GS-15005

General Supplemental Specifications for Highway and Bridge Construction

Effective Date
October 17, 2017

THE STANDARD SPECIFICATIONS, SERIES 2015, ARE AMENDED BY THE FOLLOWING MODIFICATIONS, ADDITIONS, AND DELETIONS. THESE ARE GENERAL SUPPLEMENTAL SPECIFICATIONS AND SHALL PREVAIL OVER THOSE PUBLISHED IN THE STANDARD SPECIFICATIONS.

Figure 4137.01-01: AASHTO T 350 Test Temperature by County (°C)

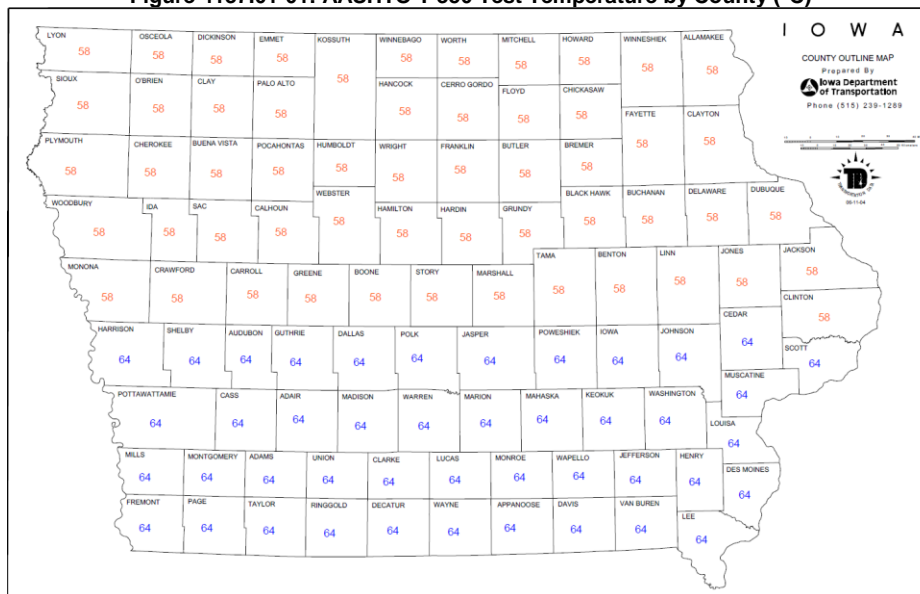
(Delete figure)
